REGIONAL REVIEW NOTIFICATION

Name of Proposal: Kingston Village

Review Type: Development of Regional Impact

Preliminary Report:	June 30, 2005	DEVELOPMENT OF REGIONAL IMPACT	Project:	Kingston Village #788
Final Report Due:	July 30, 2005	<u>REVIEW REPORT</u>	Comments Due By:	July 14, 2005

Conceptual Site Plan

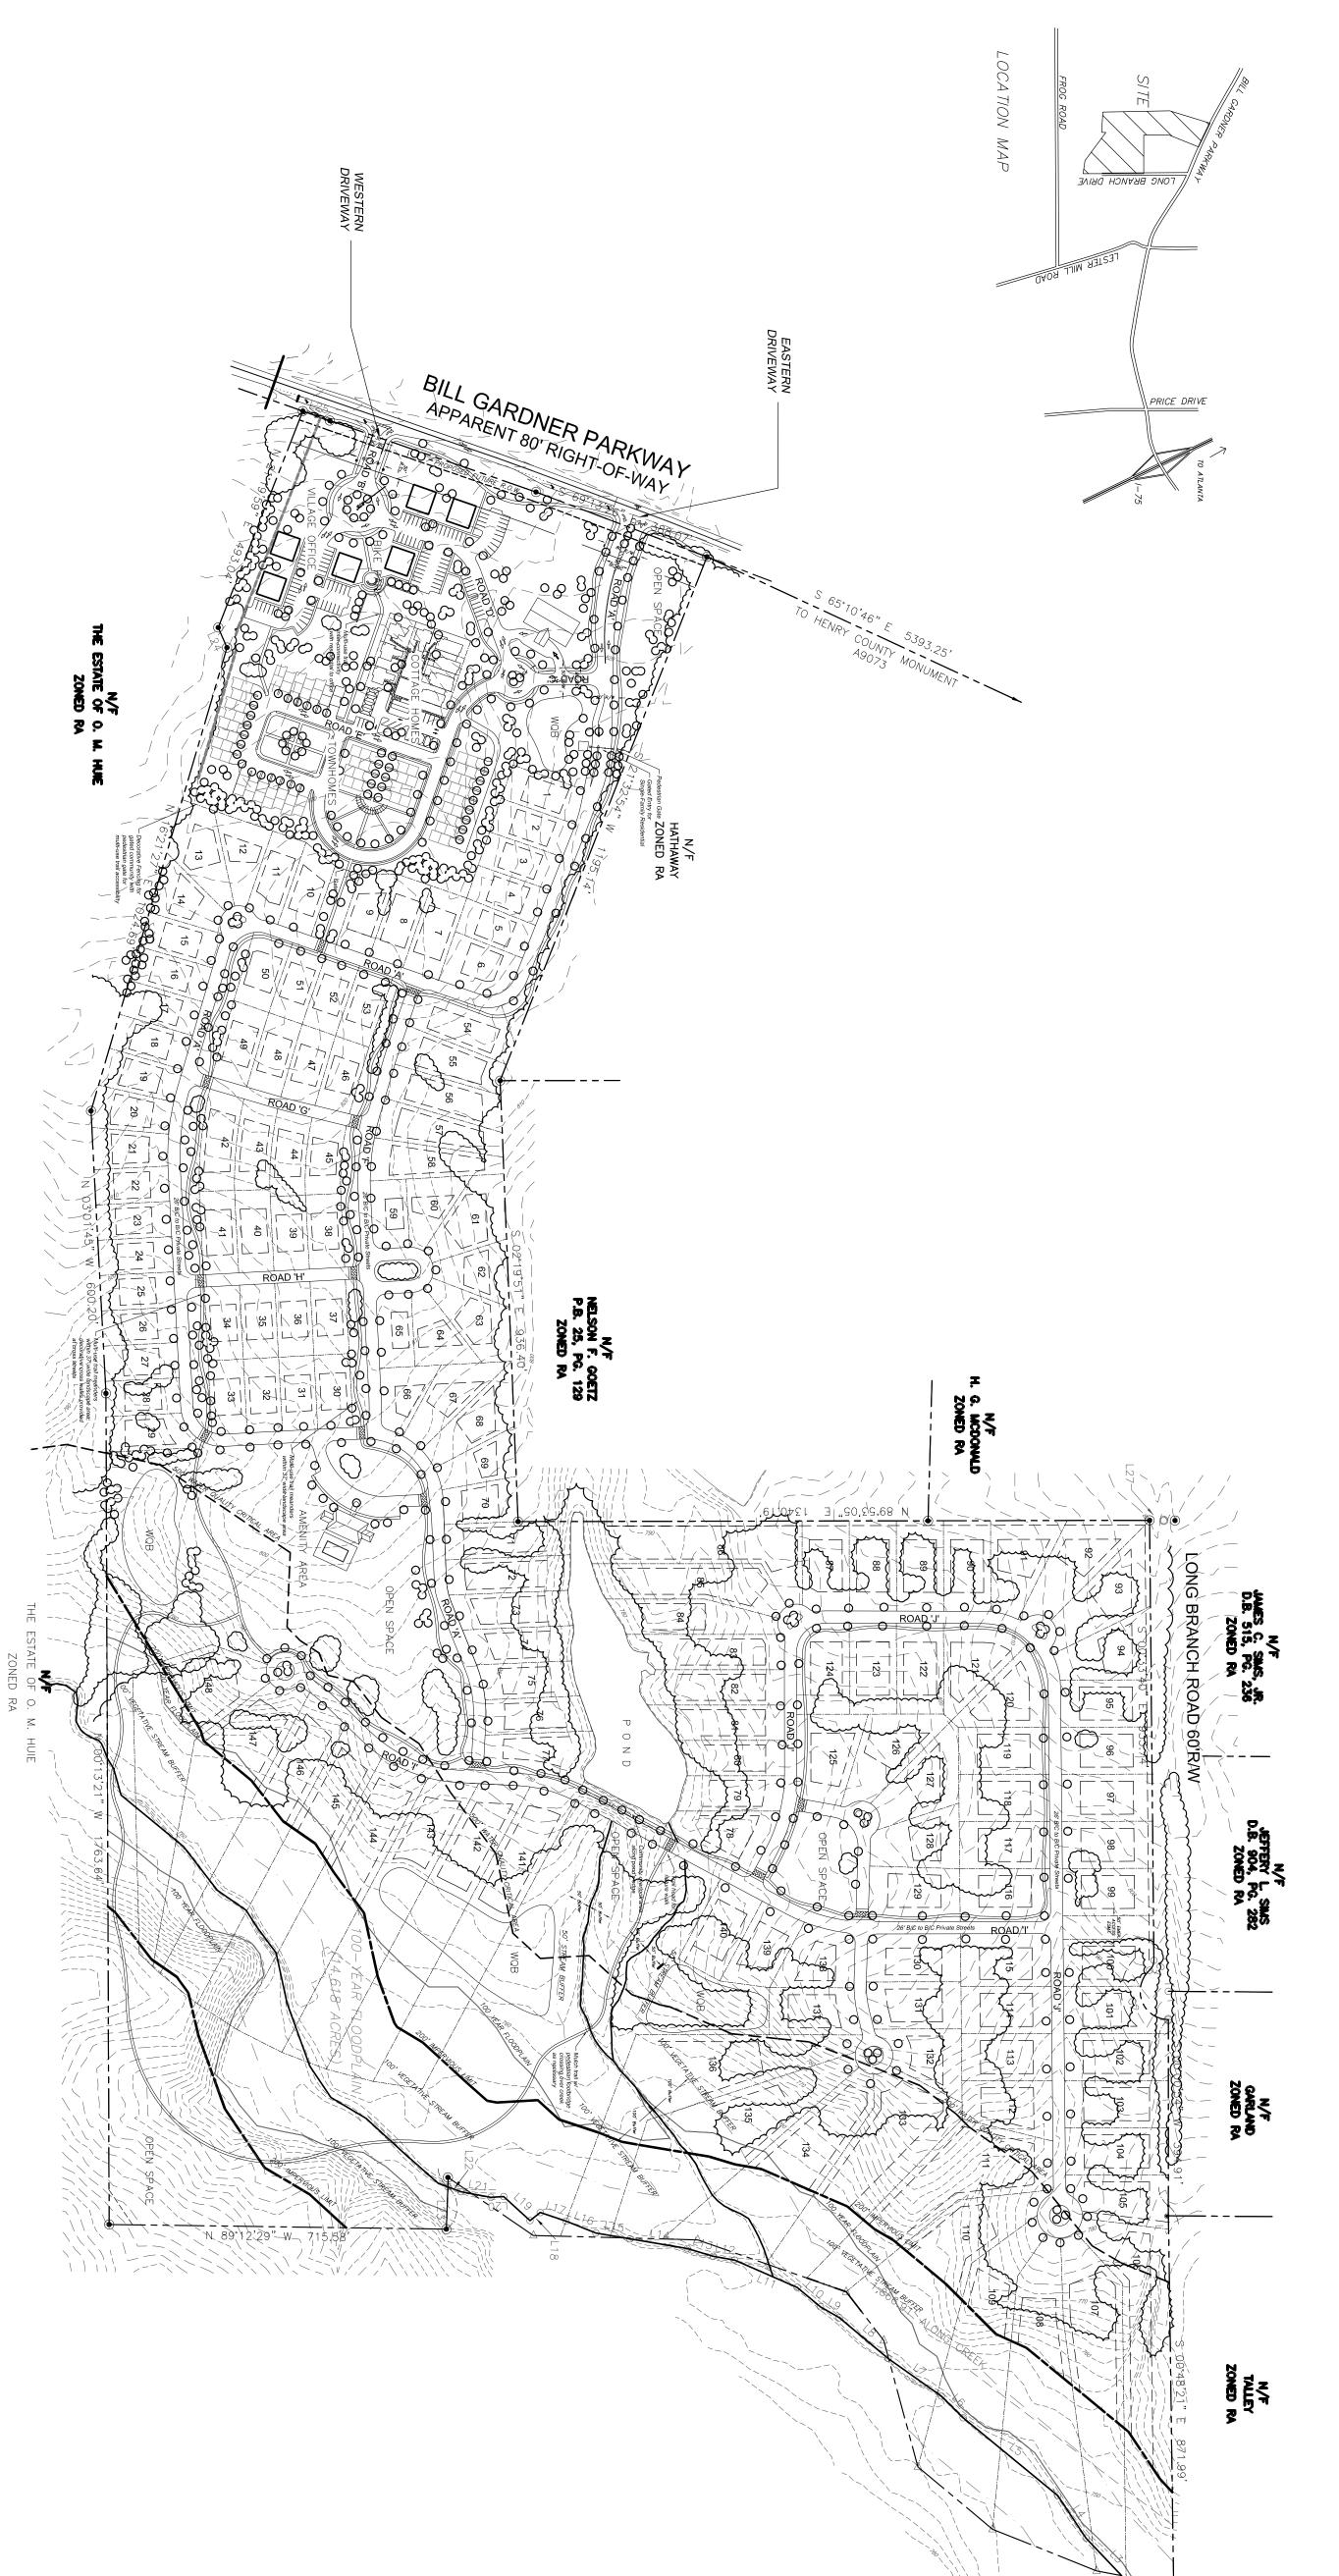
ARC has reviewed the site plan and has several concerns about the revisions that have been made since the Form 1 meeting in May. The developer submitted two memos to ARC, attached at the end of this report, that need to be revised to reflect the current site plan that was submitted for review.

The site plan submitted for the review notes several locations where gates into the single family residences would be put in place. It is strongly recommended the single family residences not be gated

from the village office and townhome component of the development. Gating both the street entrances and the pedestrian entrances to the single family residences will discourage connectivity throughout the development, especially pedestrian connectivity. It certainly deters the residents of the townhomes to use the amenity center located in the single family residences neighborhood. ARC's development policies encourage connectivity between uses and pedestrian friendly environments. The policies also promote street patterns, multiple access points, sidewalks and trails, and community design that encourage pedestrian trips that links to parks, community facilities, and other public places.

The current site plan does not indicate how stormwater runoff will be managed. In order to address post-construction stormwater runoff quality, the project should implement stormwater management controls (structural and/or nonstructural) as found in the Georgia Stormwater Management Manual
